Functional Differences Between MSC8101 (Mask 2K42A) and MSC8103 (Mask 2K87M)

This document describes the differences between MSC8101 mask set 2K42A and MSC8103 mask set 2K87M. These differences include:

Figure 5. MSC8103 Clock Functional Block Diagram for 2K87M Mask Set

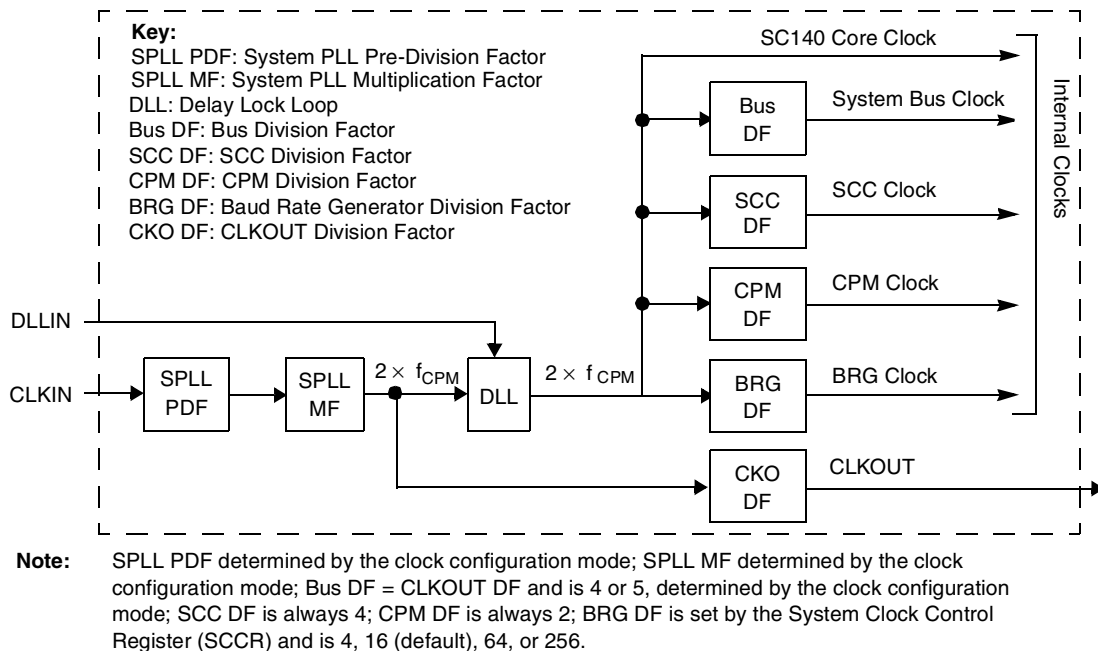
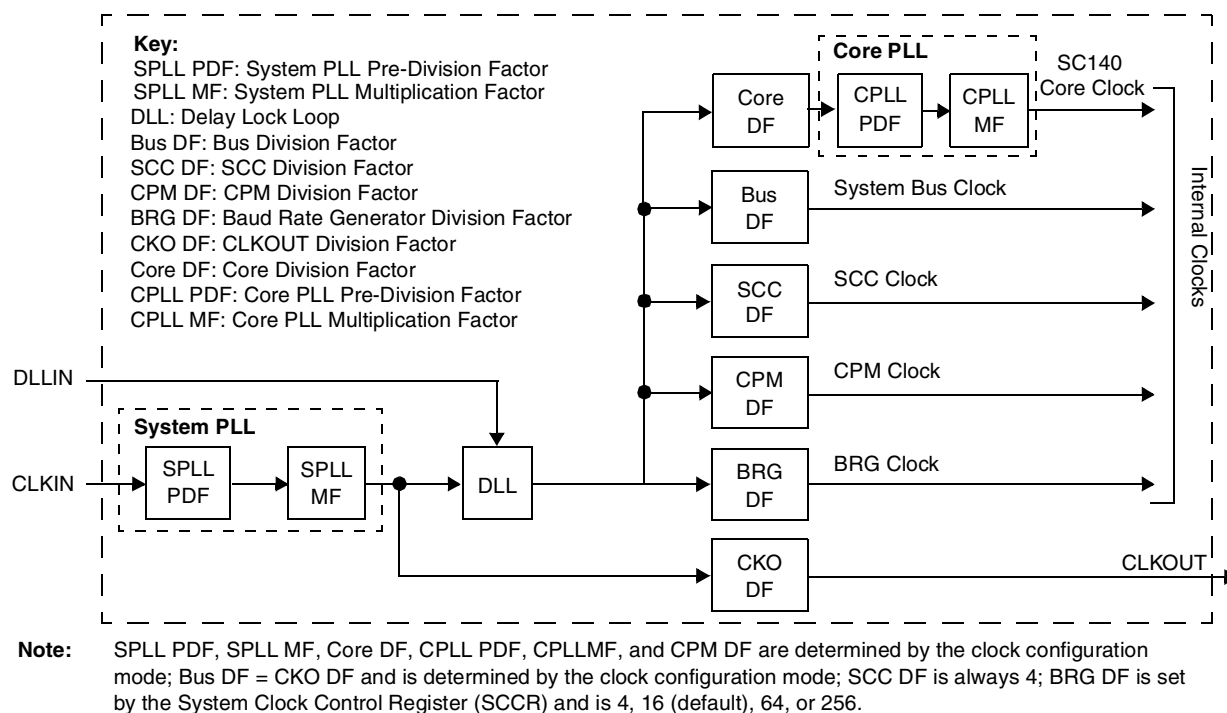
Figure 4 shows the functional block diagram for the 2K42A mask set. The 2K42A mask set contains an internal system phase-locked loop (SPLL)

Figure 5 shows the functional block diagram for the 2K87M mask set. The 2K87M mask set contains an internal system phase-lock loop (SPLL) and a core phase-lock loop (CPLL).

Figure 8. System Clock Control Register (SCCR)—0x10C80

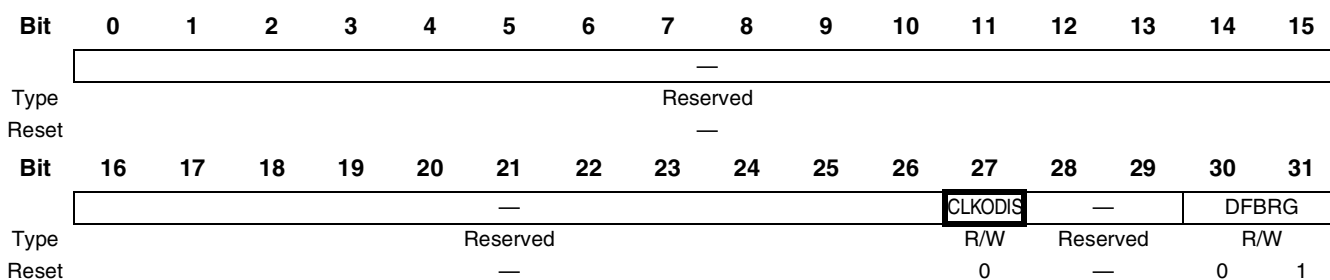
The 2K87M mask set adds a new field (CLKODIS) to the SCCR. The functionality of the common field (DFBRG) is the same. **Figure 8** shows the register layout and **Table 12** lists the bit descriptions.

Figure 10. HDI16 Host Request Structure

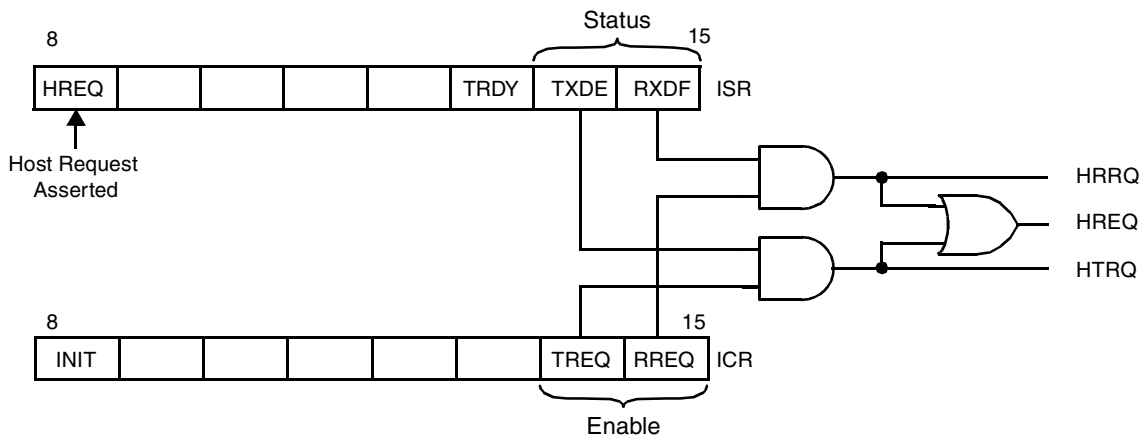
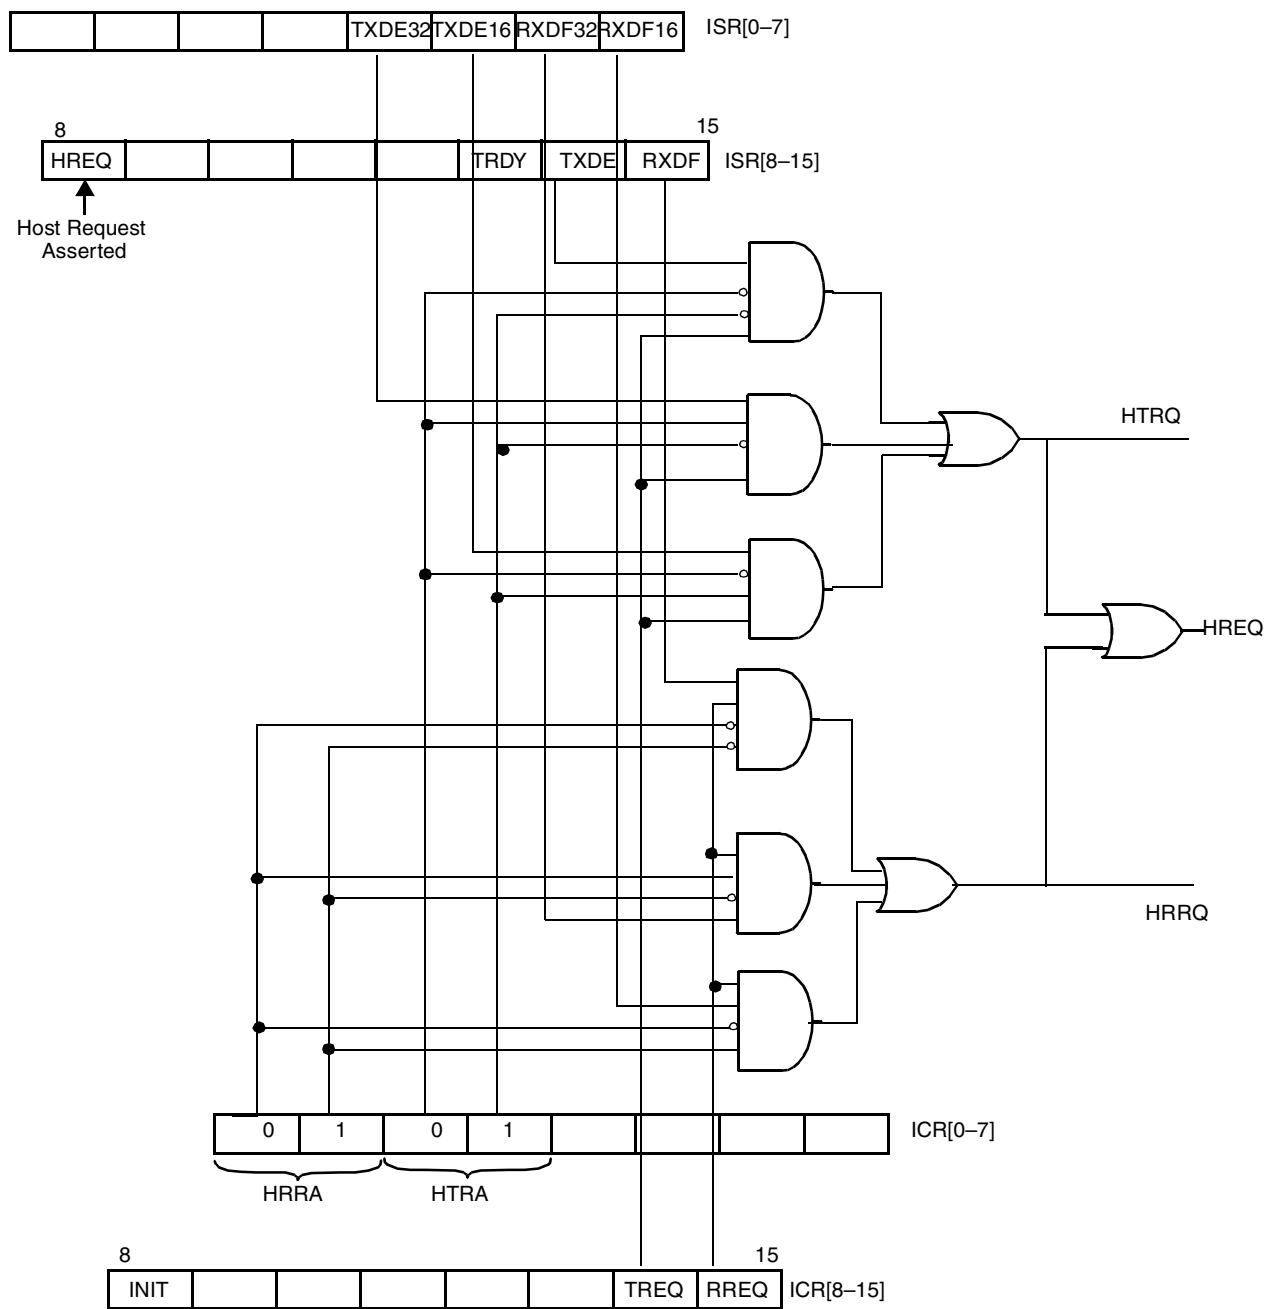
When HREQ is connected to the host processor interrupt input, the HDI16 asserts HREQ to request service from the host processor. HREQ is asserted when TXDE is set and/or ISR[RXDF] is set, and the corresponding enable bit (TREQ or RREQ, respectively) is set, as **Figure 9** shows.

When HREQ is connected to the host processor interrupt input, the HDI16 asserts HREQ to request service from the host processor. HREQ is asserted according to the programming of ICR[HTRA] and the status bits TXDE, TXDE16, and TXDE2 when ICR[TREQ] is set, or according to the programming of ICR[HRRA] and the status bits RXDF, RXDF16, and RXDF32 when ICR[RREQ] is set, as **Figure 10** shows. The programming of HRRA or HTRA chooses the status bit, and depending on its value, HREQ is asserted or deasserted.

Figure 12. 2K87M Mask Set 32 KB Dual-Port RAM Memory Map

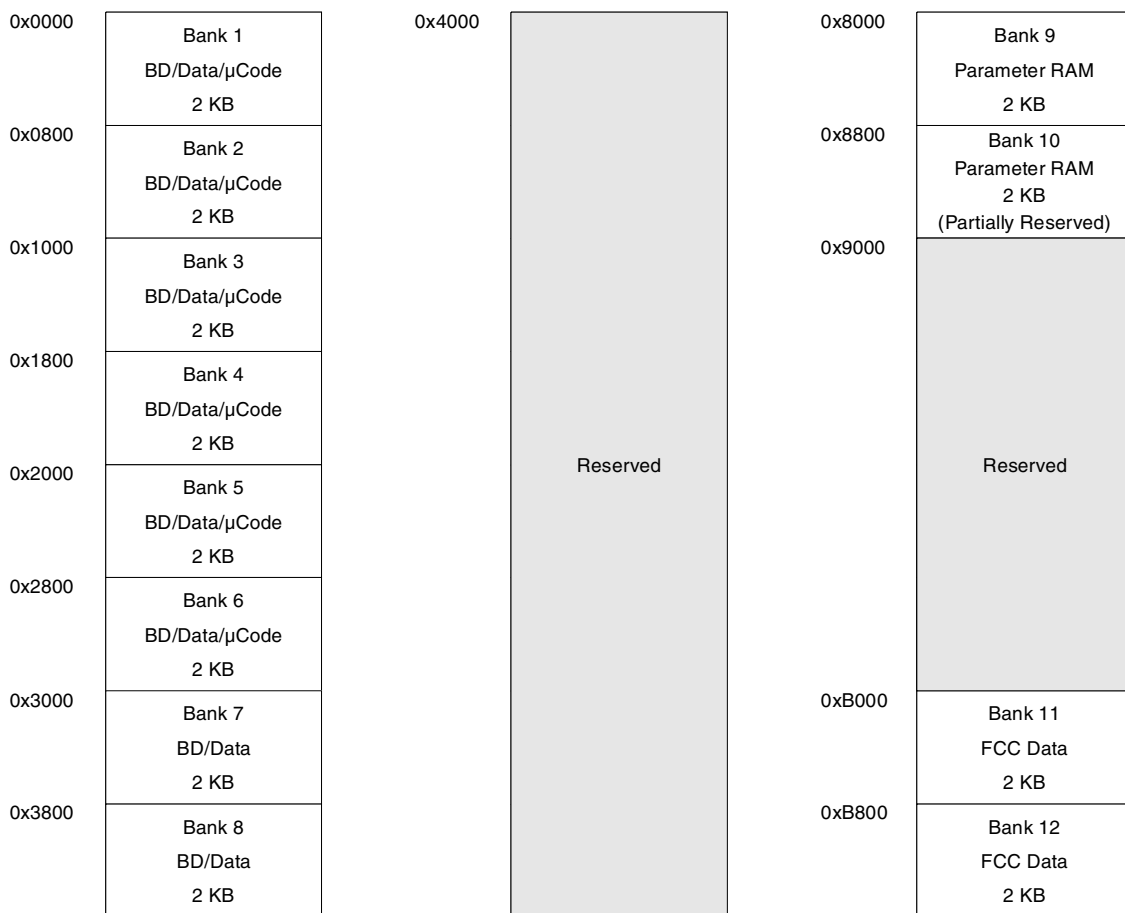
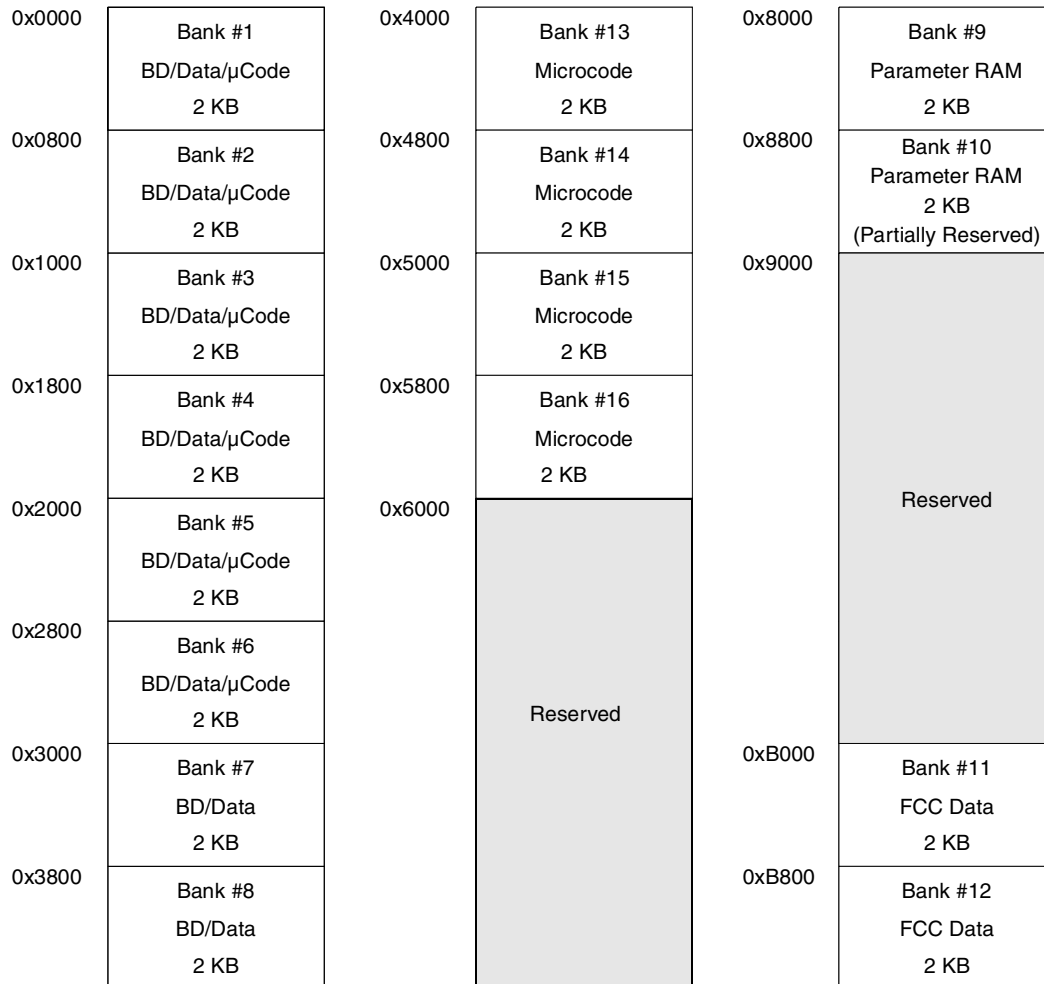
Figure 11 shows the MSC8101 2K42A mask set memory map of the dual-port RAM.

Figure 12 shows the MSC8103 2K87M mask set memory map of the dual-port RAM.

Figure 13. SI Block Diagram

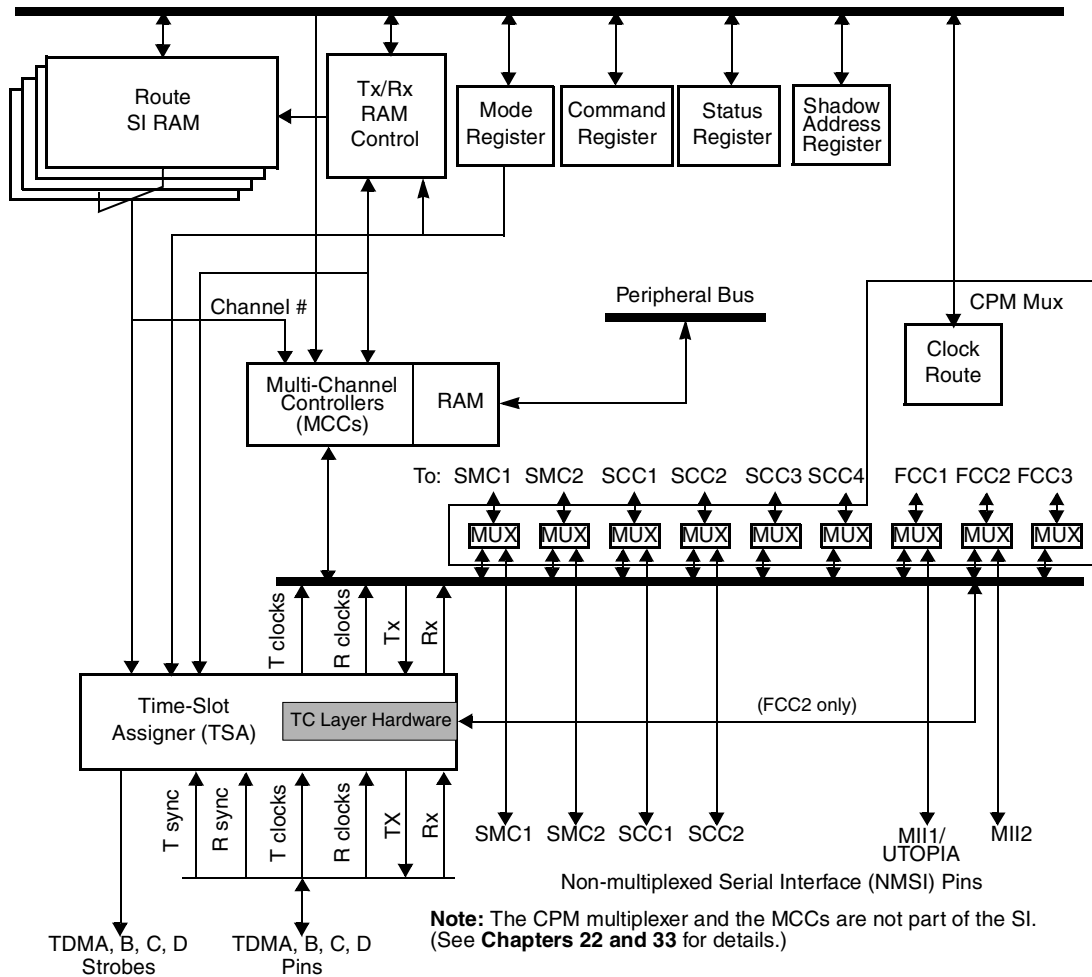
Figure 13 shows a block diagram of the SI blocks and TSA. The TSA also contains transmission convergence (TC) layer hardware.

Note: TC layer support for ATM (FCC2 only) with TC layer 1 supported through TDMA1 and TC layers 6–8 supported through TDMB2, TDMC2, and TDMD2, respectively.

Figure 14. Serial ATM Interface Using FCC2 and TC blocks (single channel)

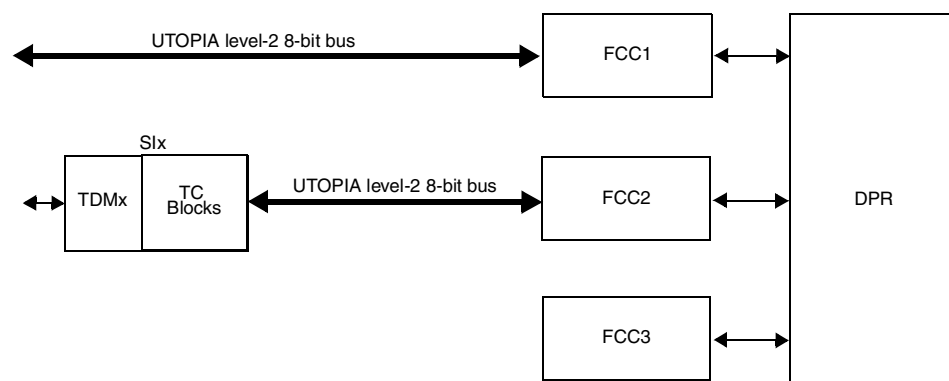
As shown in **Figure 14**, all TC blocks are internally connected to FCC2. In addition, **Figure 14** shows FCC1 connected to a UTOPIA 8-bit MPHY bus that can be routed outside and operated independently from the TC block

Figure 15. TC Layer Block Diagram

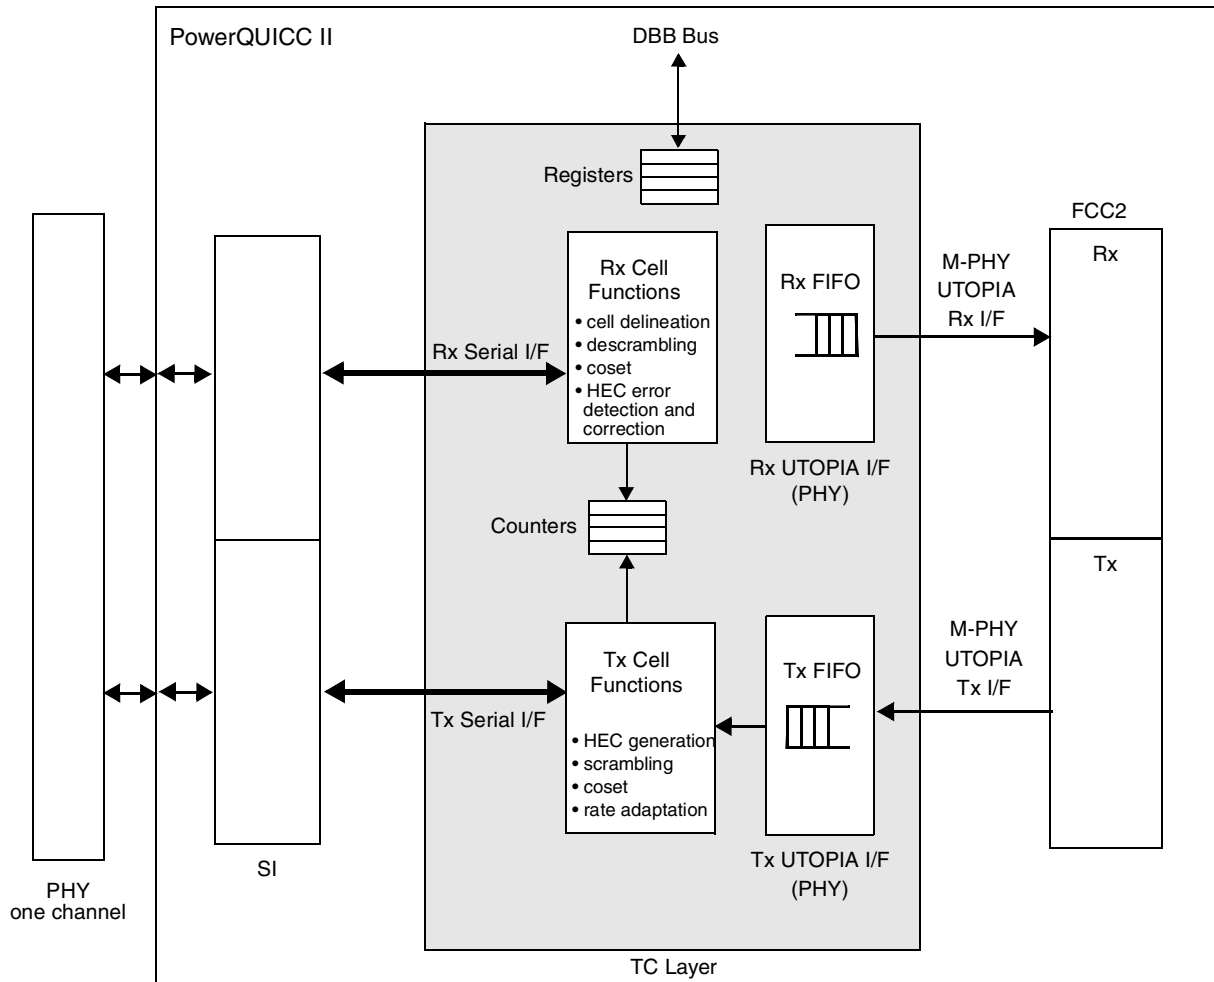
The TC layer block is shown in **Figure 15**. The transmit and the receive parts are independent; the only case in which they are synchronized is in cell echo mode.
